**SUSQUEHANNA STEAM ELECTRIC STATION
PROPOSED AMENDMENT NO. 288 TO LICENSE NPF-14 AND
PROPOSED AMENDMENT NO. 256 TO LICENSE NPF-22:
REVISION TO TECHNICAL SPECIFICATION 3.8.1
(UNIT 1 ONLY) AND FIGURE 4.1-2
PLA-6042**

**Docket Nos. 50-387
and 50-388**

Technical Specification 3.8.1 and Figure 4.1-2

Figure 4.1-2

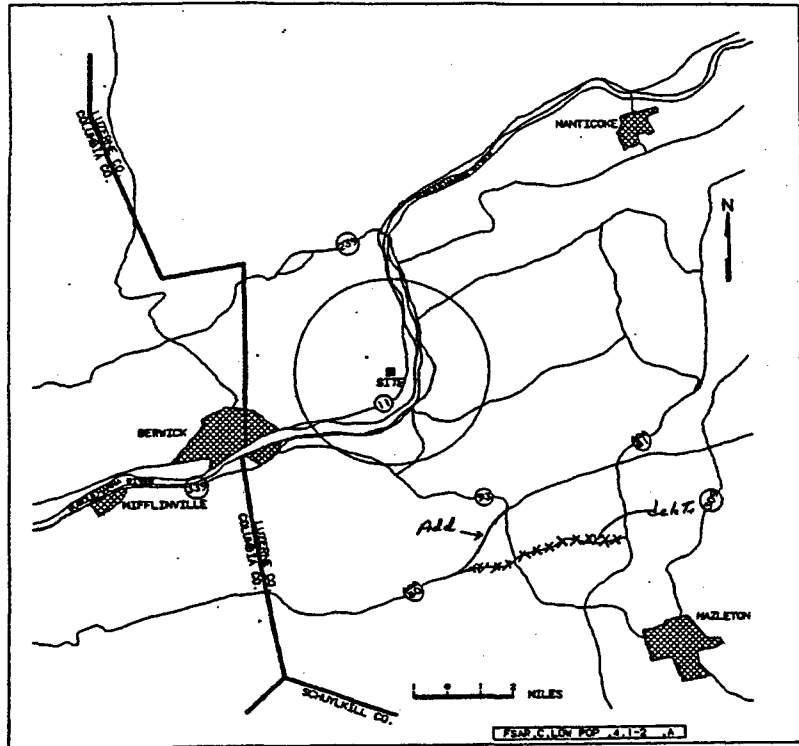
The proposed change revises the routing of Interstate Route 80 (I-80) on Figure 4.1-2. Figure 4.1-2 incorrectly shows that I-80 intersects with Interstate Route 81 (I-81) and becomes part of I-81.

This change revises the routing of I-80 on Figure 4.1-2 of Units 1 and 2 Technical Specifications as follows:

Low Population Zone

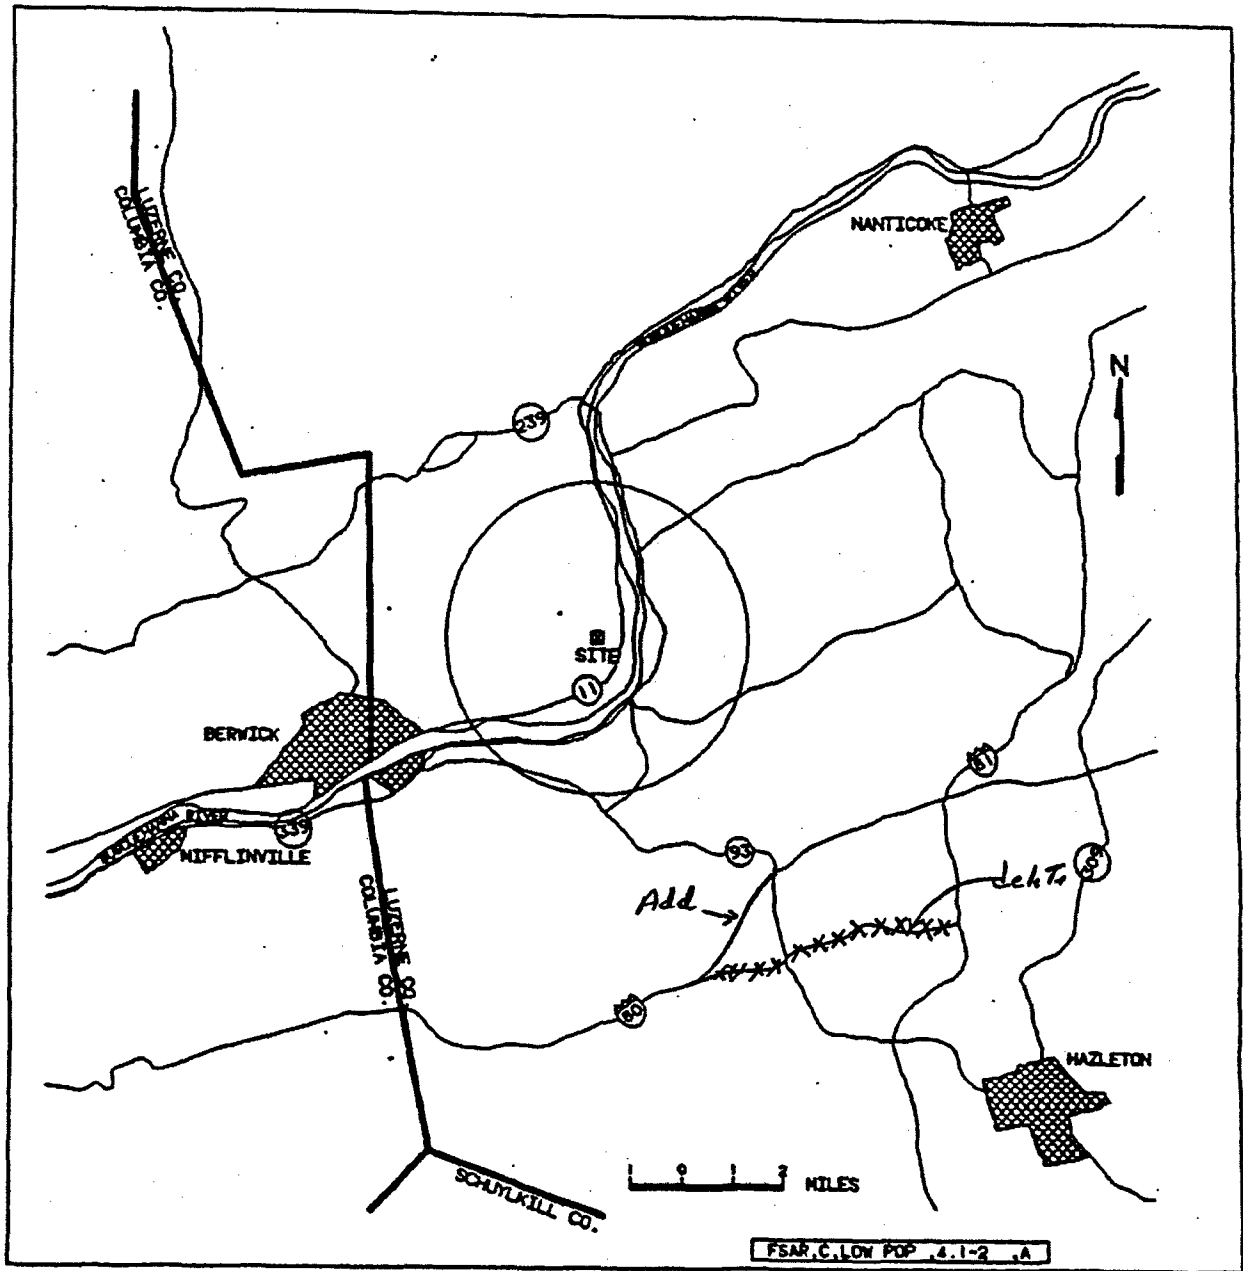
In 1998 during the conversion of the Technical Specifications to the Improved Technical Specifications, the routing of I-80 was inadvertently drawn incorrectly in Technical Specification Figure 4.1-2.
